**OceanView at Cumberland, Tuttle Road, Cumberland
Revised Preliminary Subdivision Plan Submittal –*ADDENDA-1A*
(Map R04 Parcels 4B, 4D, 4E and 5)**

Subject: Peer Review of OceanView At Cumberland
Major Subdivision and Site Plan Application – Preliminary Review
Tuttle Road, Cumberland, Maine

Subject: Peer Review of OceanView At Cumberland
Preliminary Stormwater Review for Major Subdivision and Site Plan Application
Tuttle Road, Cumberland, Maine

PROGRESS PLAN
NOT FOR CONSTRUCTION

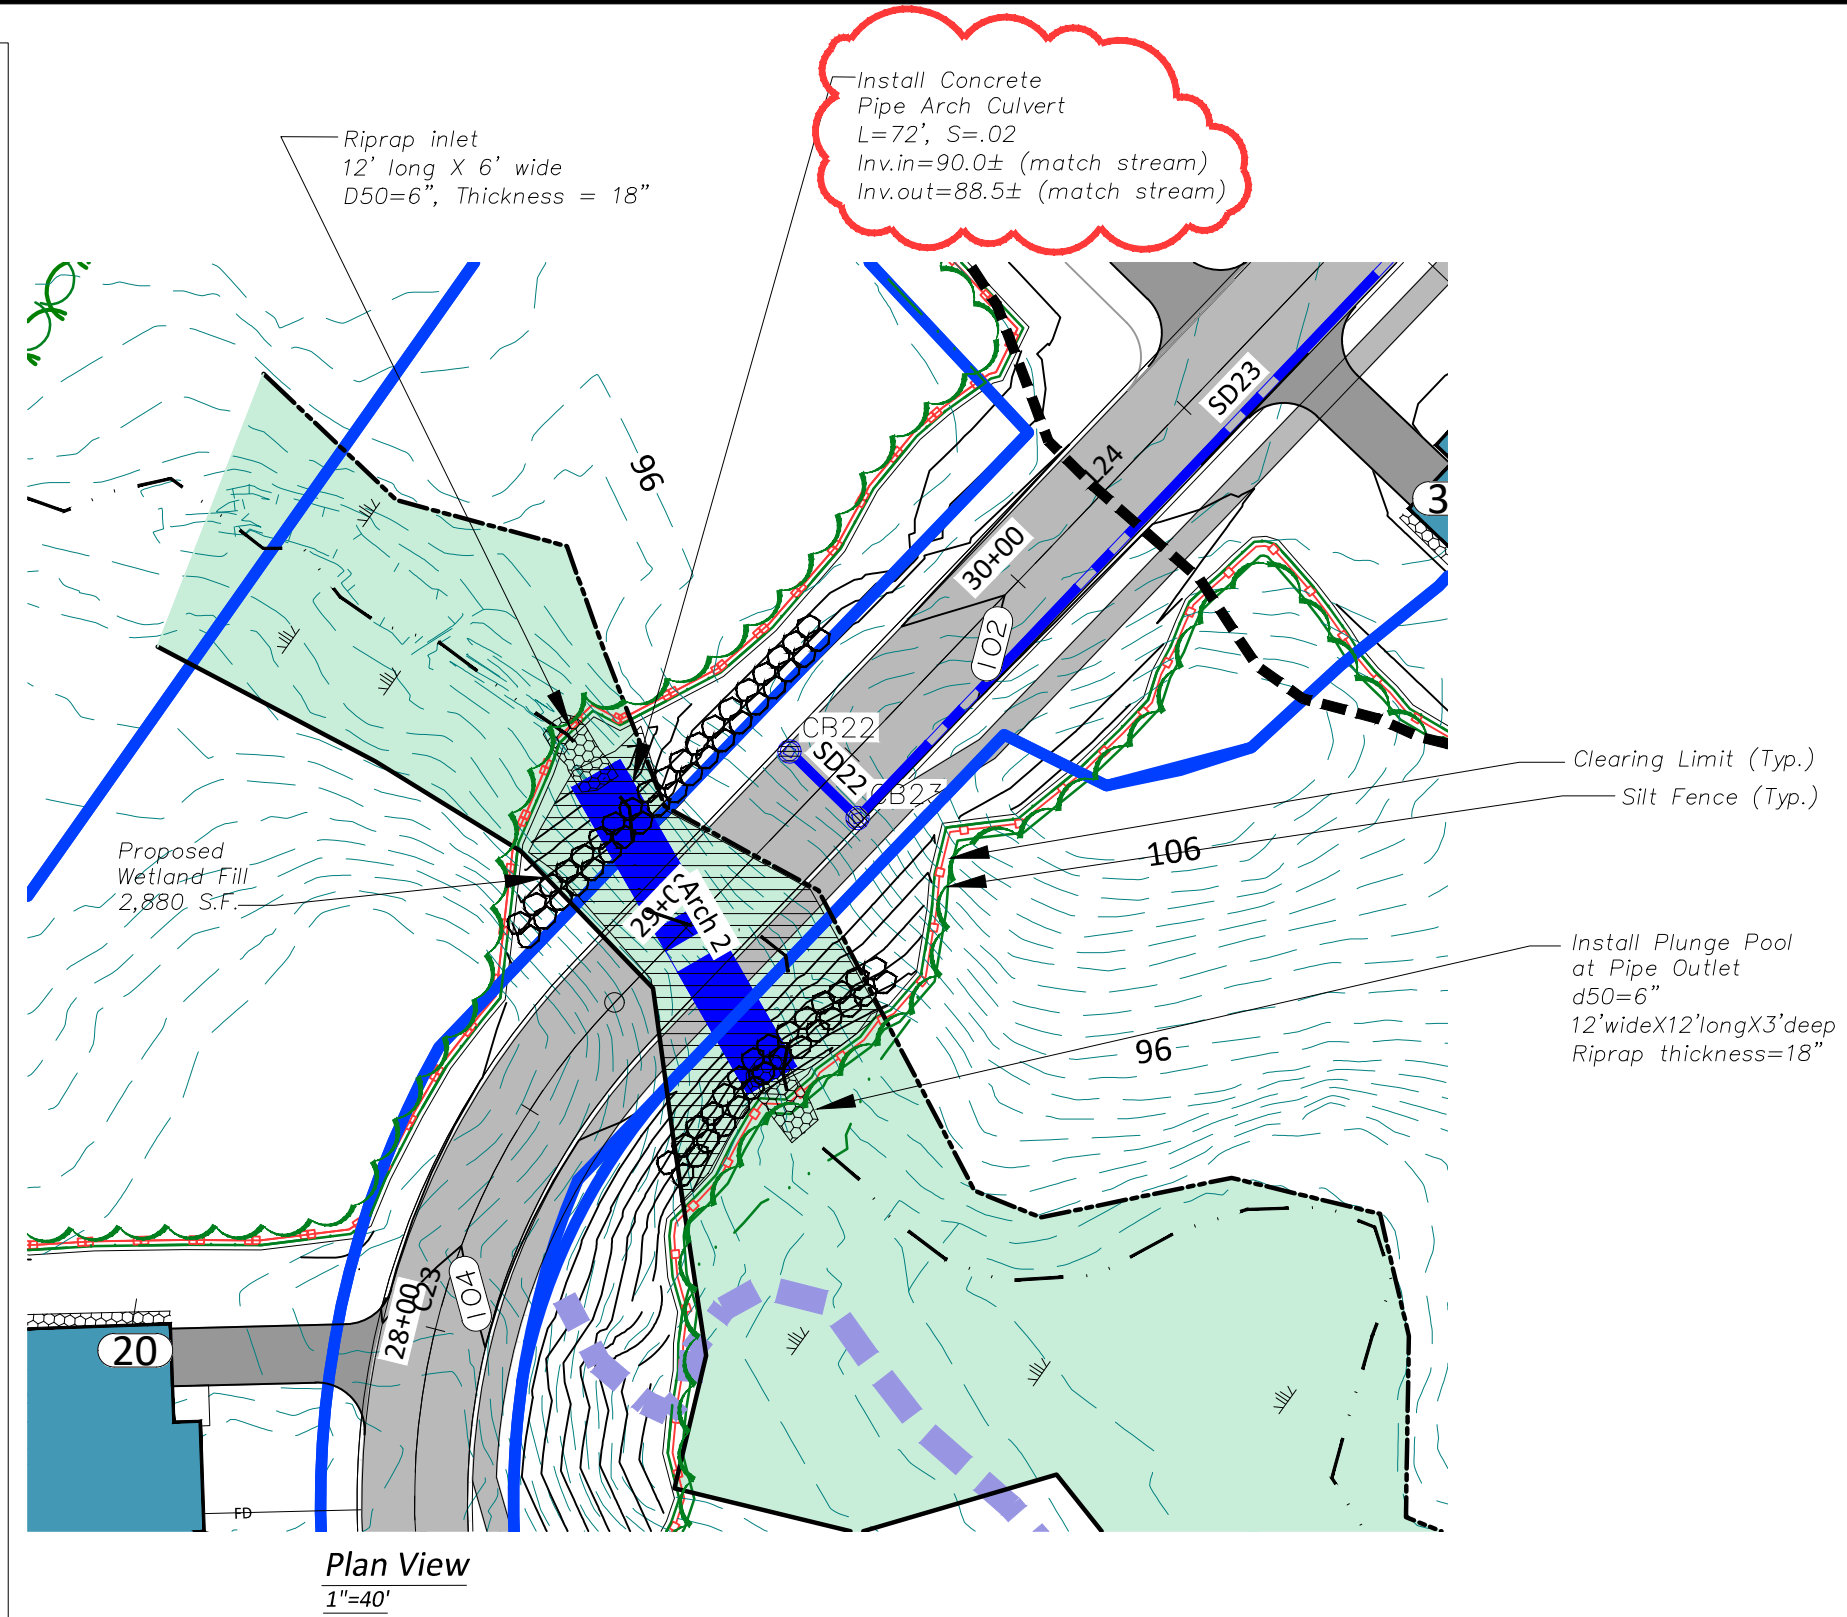
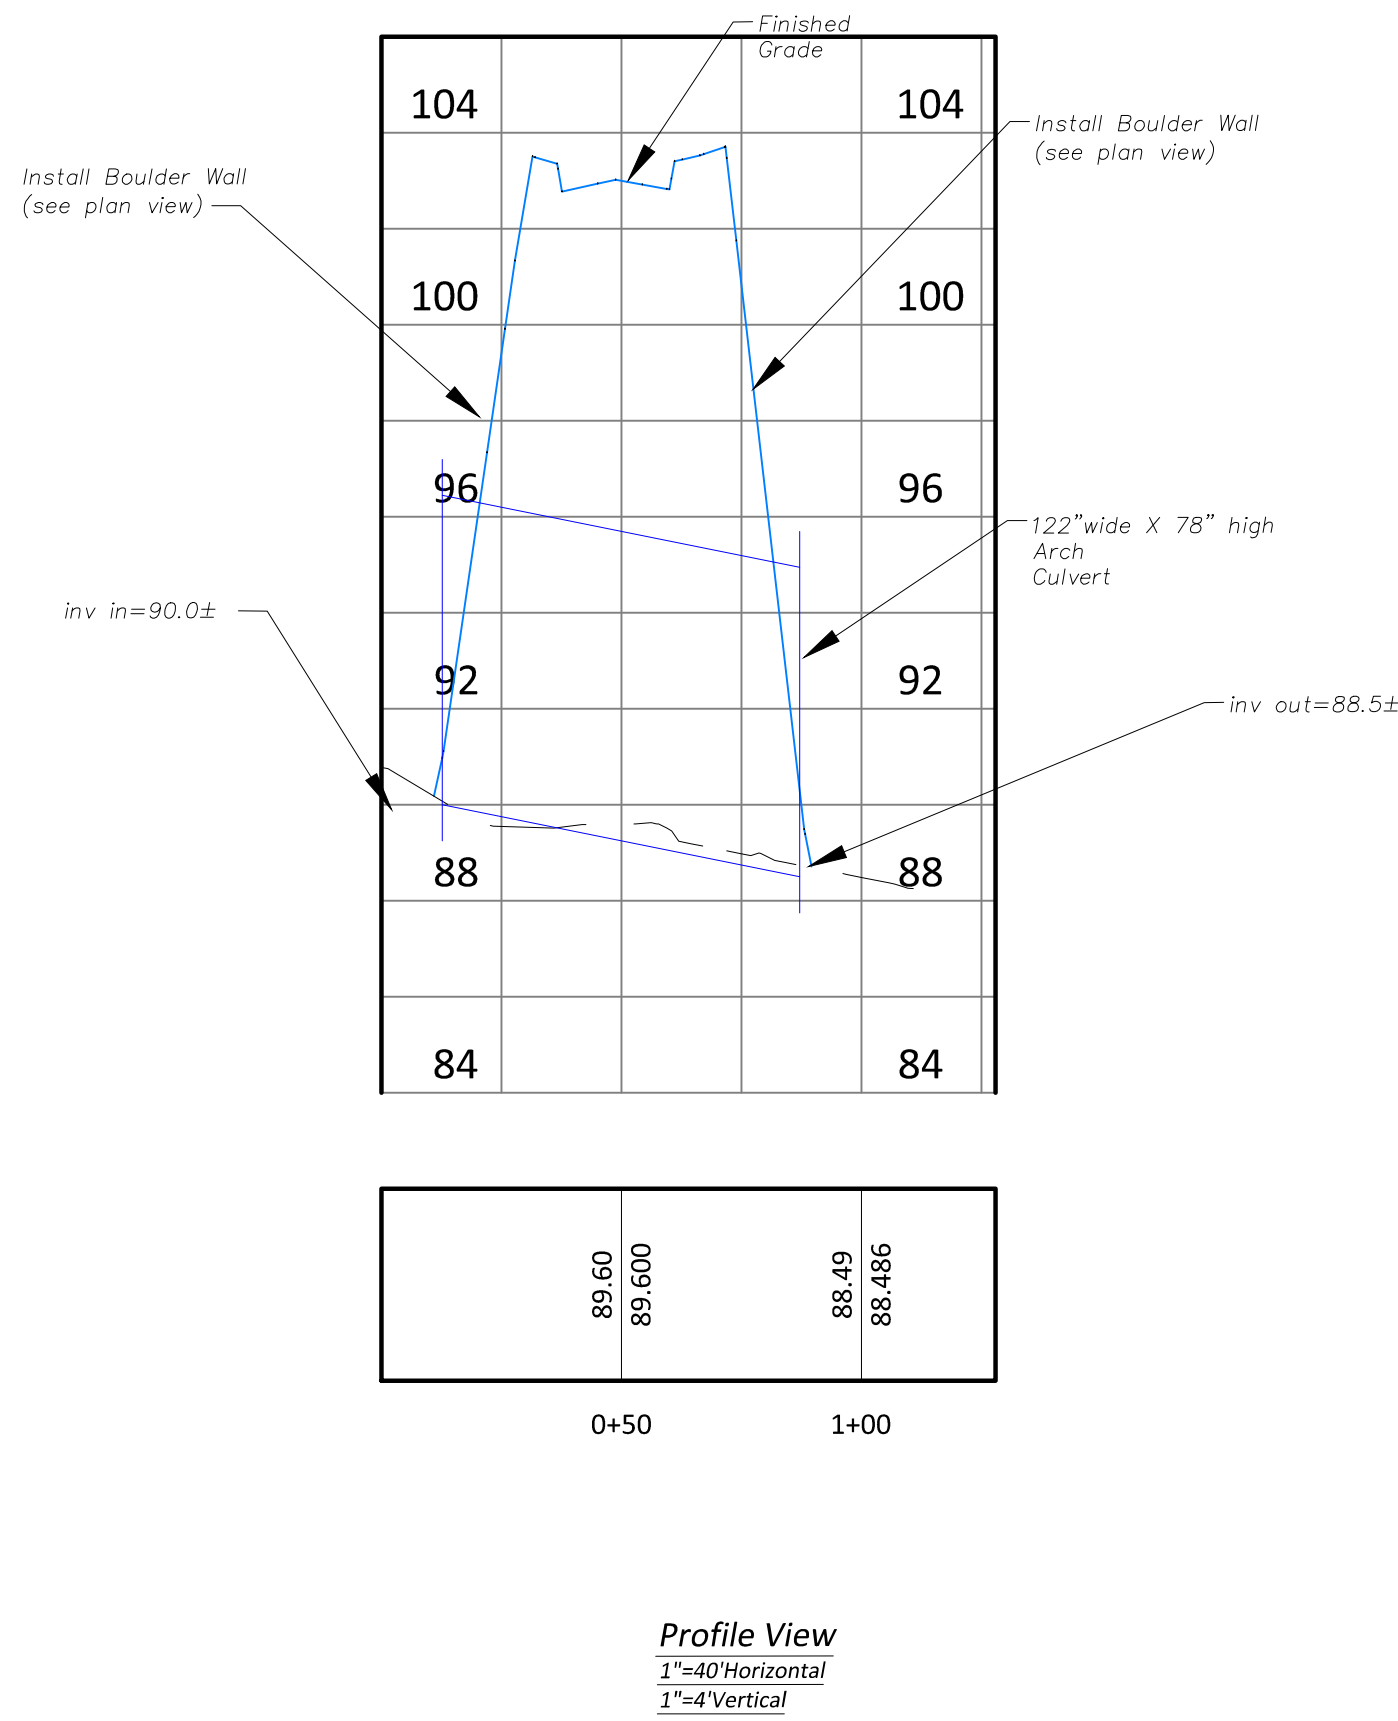
39. Arch 2 Culvert Details C21 - Profile does not include a sidewalk. SME recommends the applicant update the plan to reflect proposed construction. *The culvert details and sizing have been revised (100 year storm design). It should be noted that final construction details will be provided for final plan submittal pending agency reviews.*
